ARMSTRONG DESIGN ENVELOPE PUMPING UNITS GENERATION 3 (IEC) | FAQ

File No: 100.220UK
 Date: AUGUST 03, 2015
 Supersedes: NEW
 Date: NEW

Series 4300
 Design Envelope: 2037-037.0
 Integrated intelligent variable speed with Sensorless control

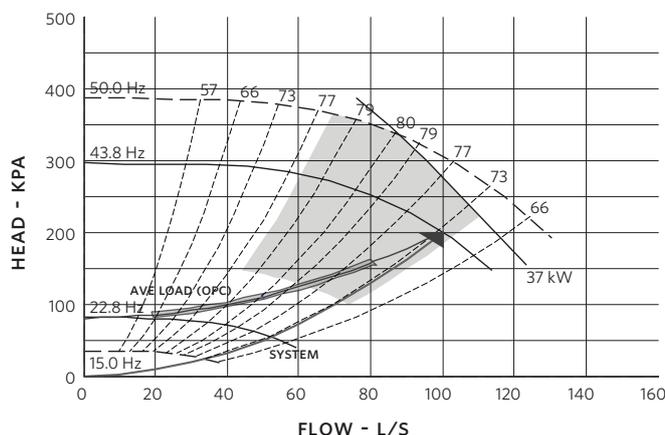
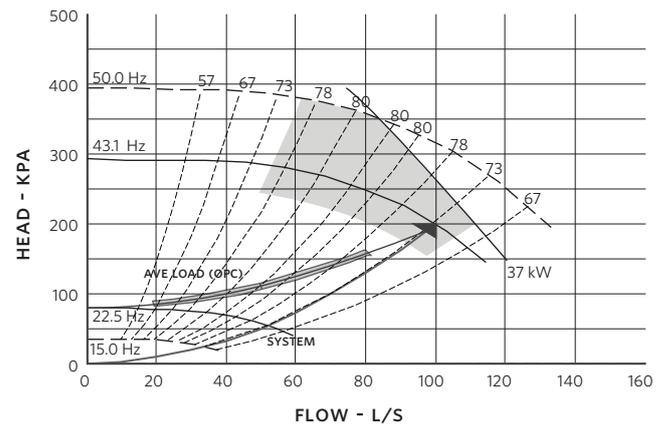
A number of changes have been made to selection envelopes. Firstly, impeller trim diameters and operating speeds have changed with the most notable difference being that many envelopes that were 60Hz nominal speed now have a lower maximum speed but albeit with a larger impeller, thereby improving hydraulic efficiency. The second noticeable change is that the yellow selection envelope has changed as can be seen in the following AOL output:

Key differences are the flow at which max motor power is reached is now model dependant and the bottom of the selection envelope has changed to prevent selections being made that are too low in the operating range which could result in minimum speed being reached before the minimum head on the control curve. The yellow selection envelope does not represent the operating limits of the pump, merely the optimised selection envelope.
